**Application Reference No: CROWN/2025/0000002**

**Proposal description: 'Buildings, Goods Vehicle parking spaces, entry lanes, refrigerated semi-trailers, staff car parking spaces, access, site infrastructure, utilities, hardstanding, landscaping and ancillary facilities and associated works; and ongoing use of the site for an Inland Border Facility and Border Control Post, operating 24 hours per day, seven days per week.'**

**Site address: Sevington Inland Border Facility, Mersham, Ashford TN25 6GE**

**Statement of Case : Kent County Council**

**Figure 1: Widening of the A20 Eastbound Arm**

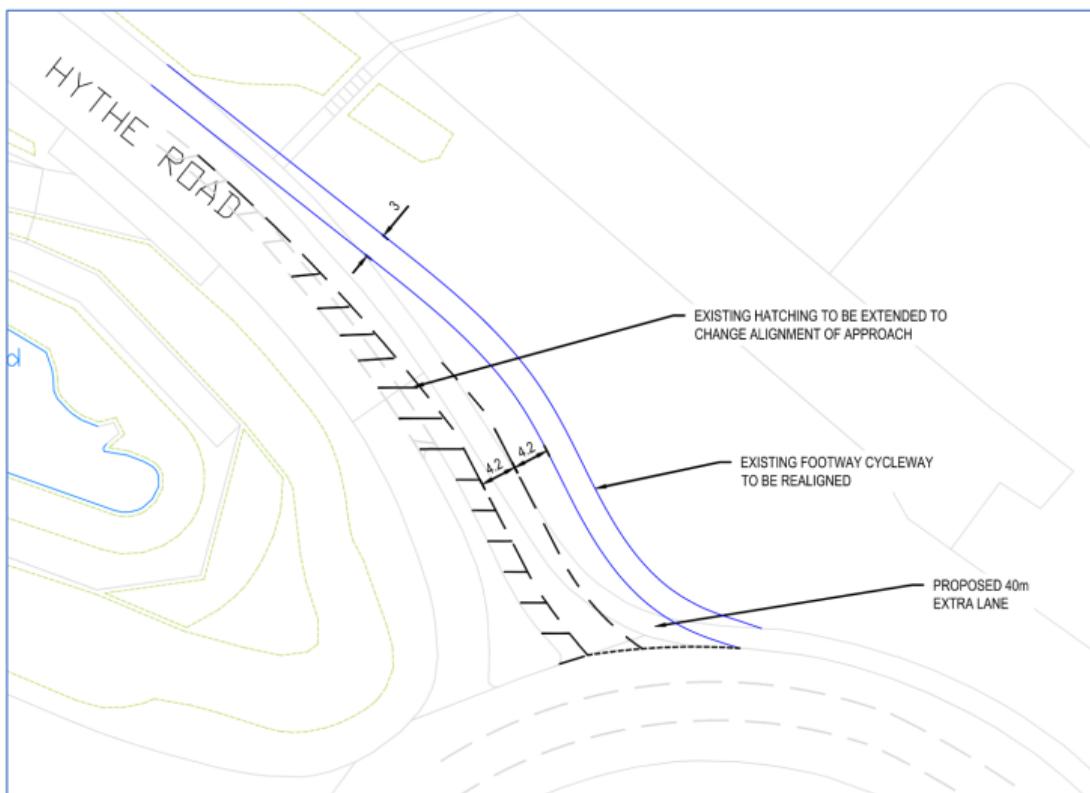
- Widening Hythe Road Eastbound approach to the roundabout entry to provide 2 lane queuing. Two 4.2 metre wide lanes are proposed. The existing footway / cycleway will be re-located further north into the highway verge to provide the 2-lane queuing.

**Figure 2: Signalisation of the A20 Westbound arms, widened circulatory and improved M20 Coast-bound on Slip**

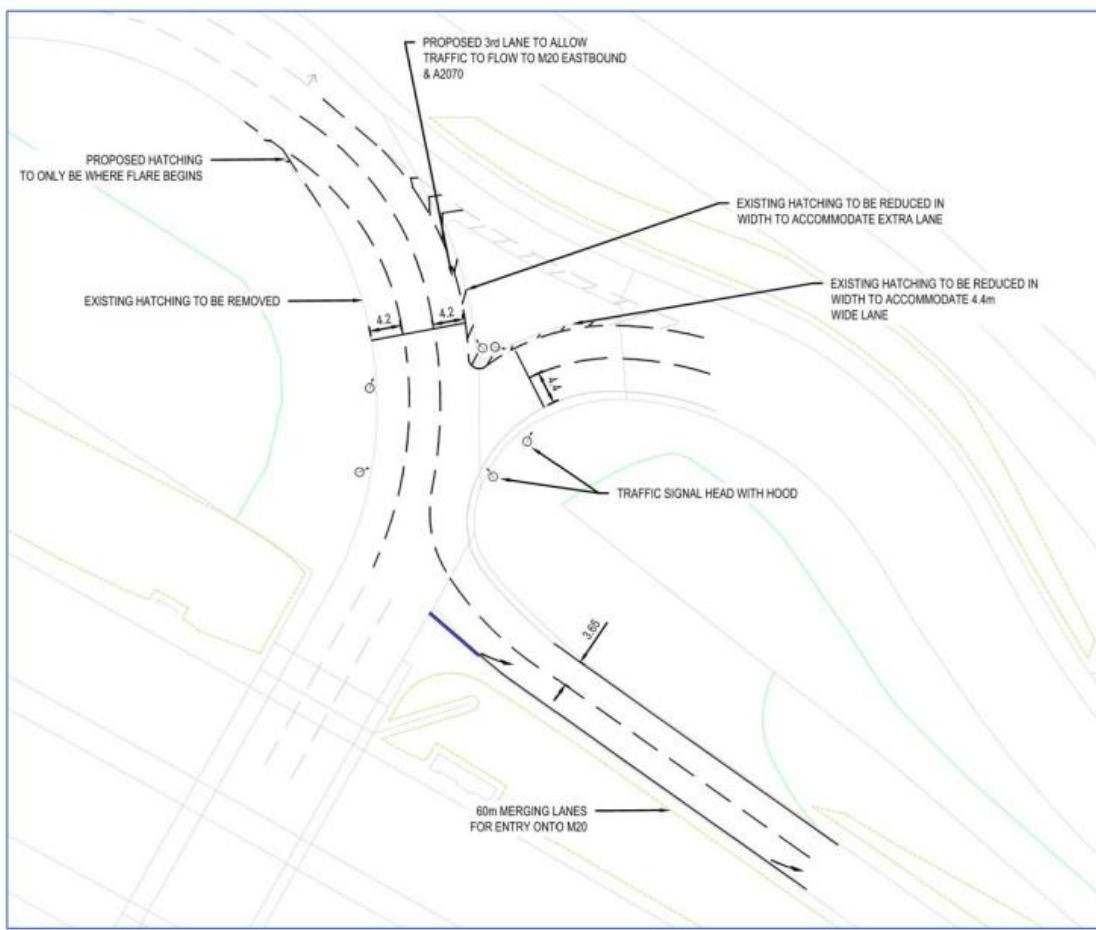
- Signalising the Hythe Road Westbound approach to the roundabout together with the circulatory.
- Changes to white lining on the roundabout to provide some additional capacity on the circulatory.
- Slight widening of the M20 J10a coastbound on-slip to allow an extra merge lane on the on-slip.
